SAFETY RECALL

Volvo Trucks North America

Date	Number	Release	Page
11.2021	RVXX2105	01	1(3)

ZF Power Steering Pump Replacement VN

Diesel Engine mounting gasket shown below

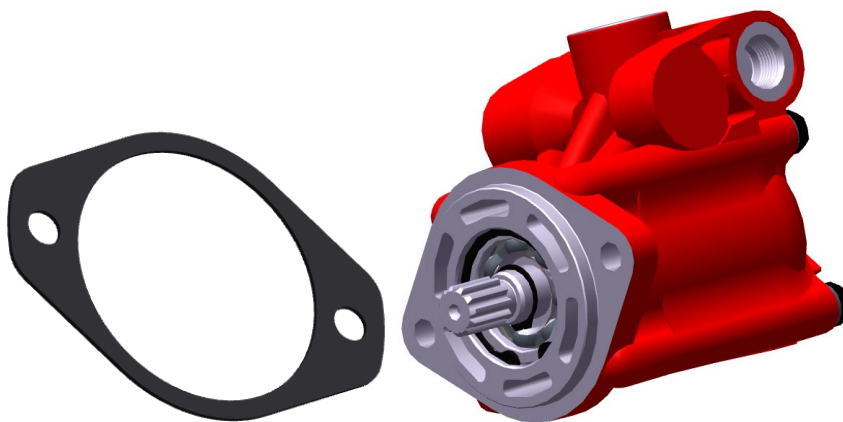
Volvo has determined that certain model year 2021 trucks may have been built with a defective power steering pump. The possible defect in the power steering pump could cause it to leak power steering fluid. If this happens, there could be a loss of power steering assist. A loss of power steering assist may result in a sudden increase in steering effort, especially at low speeds. This could increase the risk of a crash.

1. Secure vehicle for service.
2. Remove and replace power steering pump referencing IMPACT operation ID 6453-03-02-01.
3. Release vehicle to service.

Part Number	Part Names	Quantity
21123415	Power Steering pump	1
8161532	Power steering pump mounting gasket	1
977937	Line Seals	2
